# We are proposing a change in your area

<b>Reference</b>	TR121-21 Evans Bay Parade, Wellington – Cycle Lanes; Bus stops; Give way/Stop; Pedestrian crossing; Time Limited parking; NSAAT
<b>What we'd like to do</b>	<p>We propose to construct a two-way bike path and separate footpath along the western side of Evans Bay Parade, replacing the existing shared path. This project will result in changes to some areas that are currently used for on-street parking, including:</p> <ul style="list-style-type: none"><li>• rearrangement of on-street parking – there will be new parking spaces available in some places, and many spaces removed in others.</li><li>• new timing restrictions in some areas</li><li>• removal of three bus stop pairs</li><li>• new pedestrian crossings</li></ul> <p>More information about the parking changes can be found in the Parking Management Plan.</p>
<b>Why we are proposing the change</b>	<p>This proposal is about completing Tahitai, the walking and bike connection from the east. Planning started about five years ago with drop-in sessions at the ASB sports centre, a community working group, community consultation, and a 2018 Council decision and vision to develop this

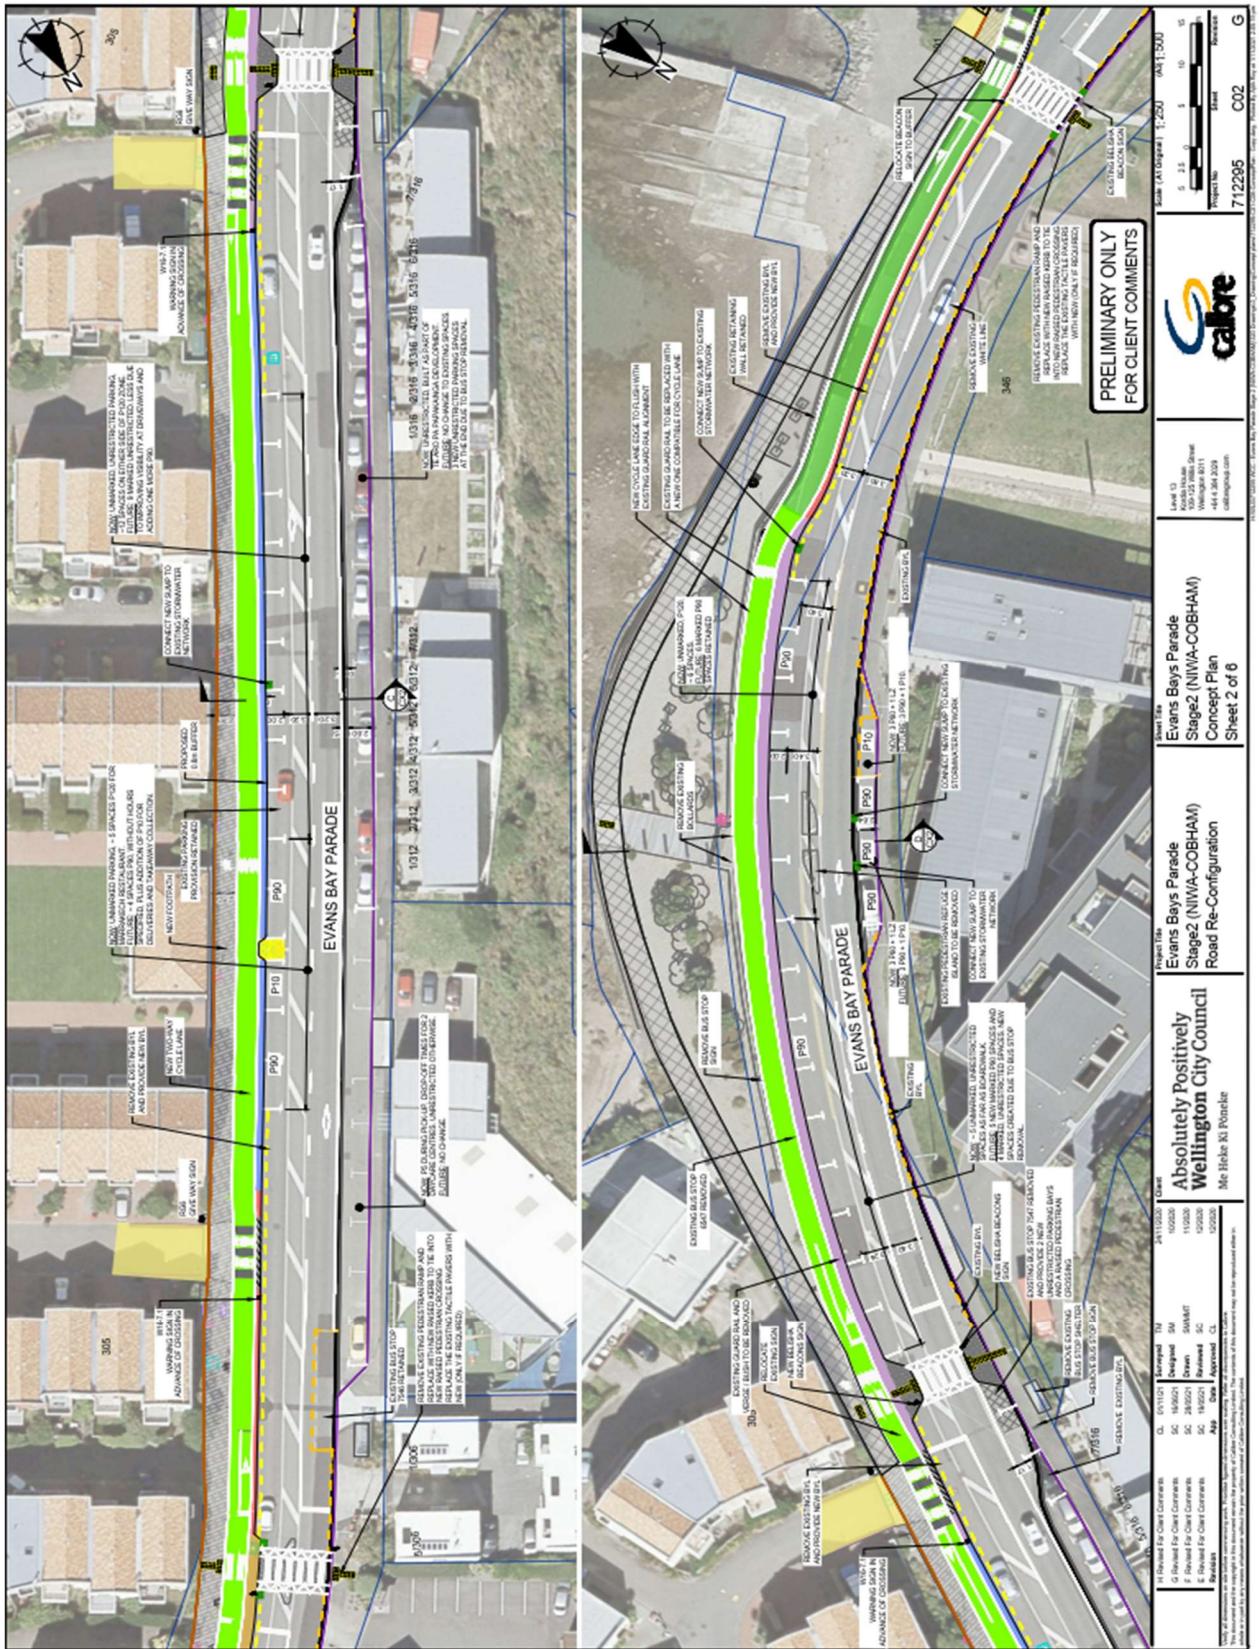
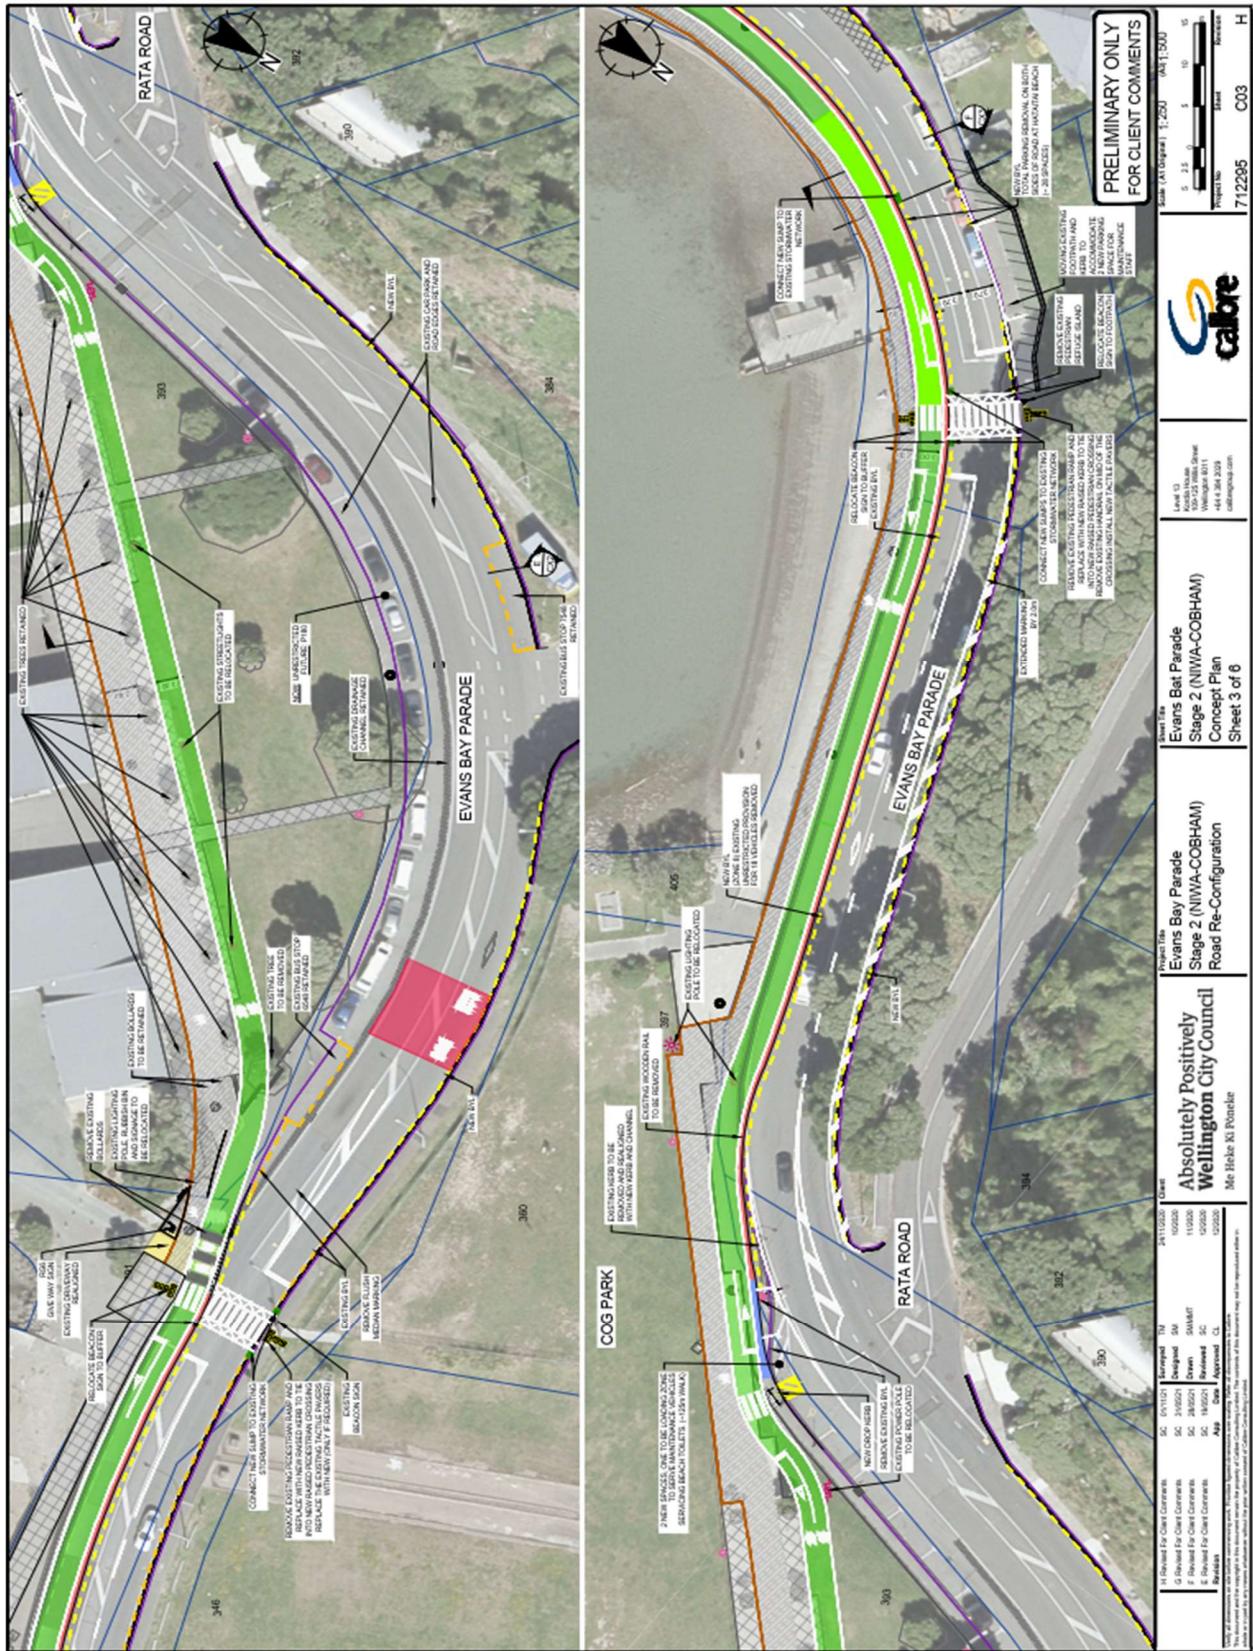
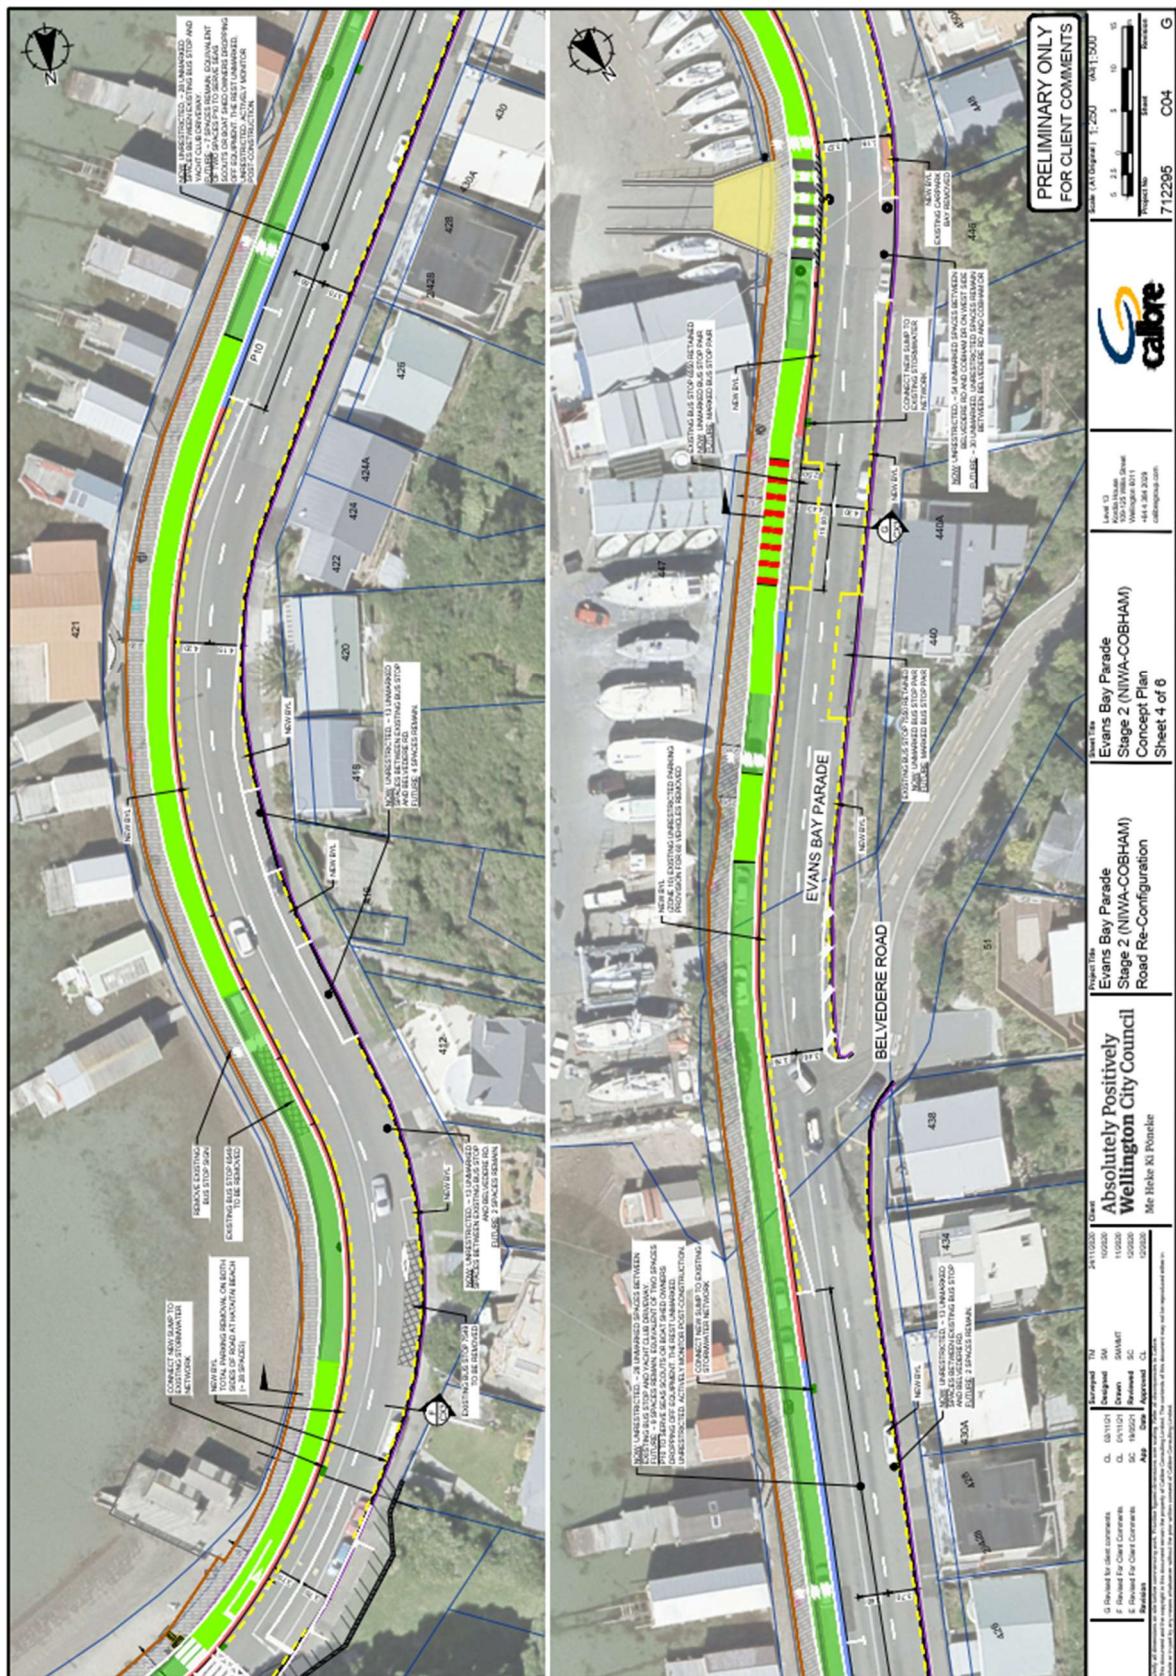
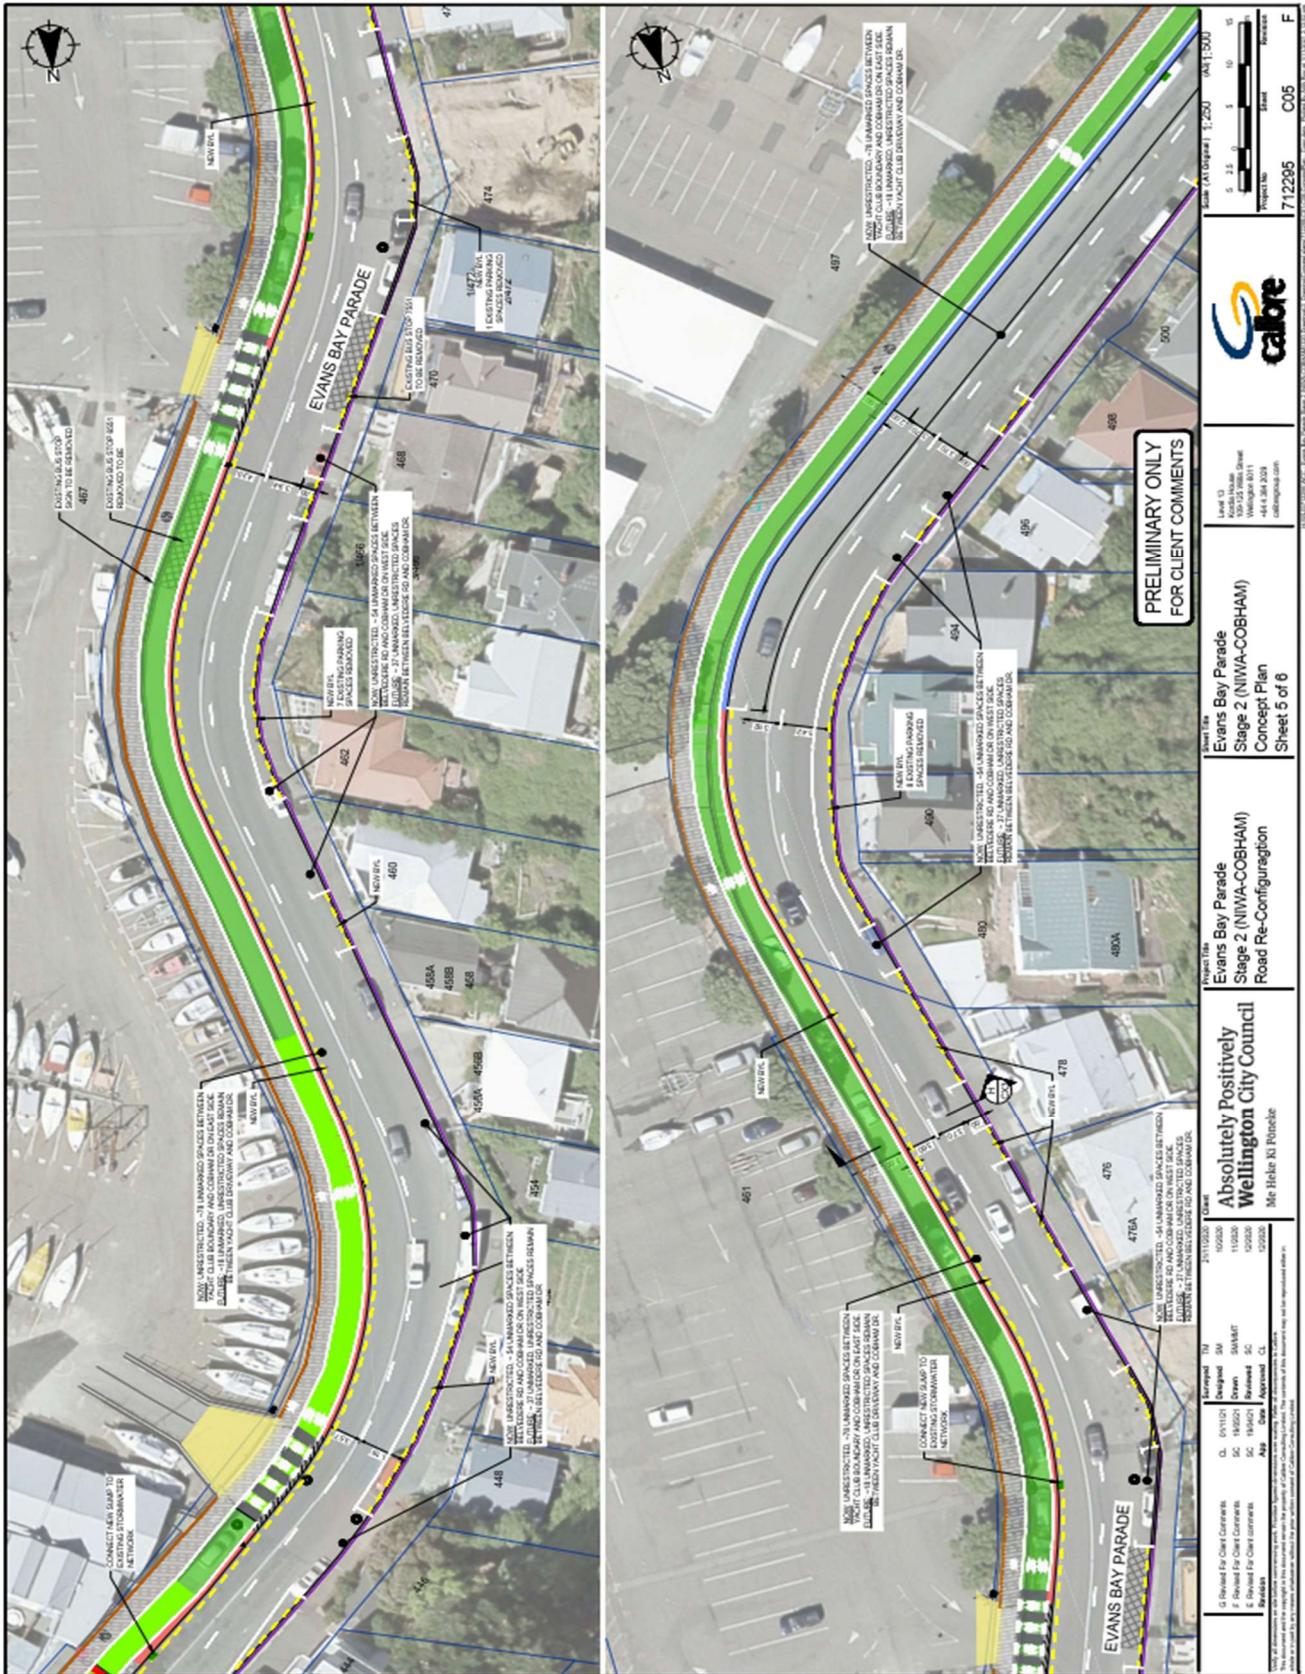
<p>A total of 1,032 responses were received. 63% of submissions support or strongly support the proposals. 33% oppose or strongly oppose. 22 of the submissions were on behalf of an organisation.</p> <p>The key theme of the opposition was the removal of on-street car parking, particularly adjacent to Hataitai beach, the boat sheds and the Evans Bay Yacht and Motor Boat Club. Those that undertake water-based recreational activities were most likely to oppose the project.</p> <p>There was also a significant number of constructive comments on what could be changed to improve the designs. Some of these have been taken on board and will be considered in more detail during the detailed design stage of the project.</p> <p>Officers propose the following changes in response to public feedback</p> <ul style="list-style-type: none"><li>• An extra 13 on-street car parking spaces being reinstated due to minor space reallocation through minor traffic lane and/or bike path narrowing<ul style="list-style-type: none"><li>○ Two adjacent to the boat sheds on east side of road</li><li>○ Four opposite boat sheds on west side of road</li><li>○ Two opposite Yacht Club on west side of road</li><li>○ Two opposite public boat ramp on west side of road</li><li>○ Three opposite southern end of marina on west side of road</li></ul></li><li>• An extra two on-street car parking spaces opposite Hataitai beach created by building into the reserve, proposed to be P15 to facilitate drop-off and pick-up</li><li>• Optimisation of the space available at the public boat ramp to provide more parking for recreational visitors to the area, particularly for water-based activities.</li><li>• Relocation of pedestrian crossing near to Greta Point Café to a location further north, resulting in four additional car parking spaces</li><li>• Conversion of one on-street car parks to provide an additional mobility parking spaces at Greta Point (P90)</li></ul> <p>These changes are reflected in the Traffic Resolution below.</p>

Red text indicates a change or an addition from the traffic resolution that went out for consultation.

Strikethrough text indicates where a proposed change has been removed from the traffic resolution that went out for consultation.
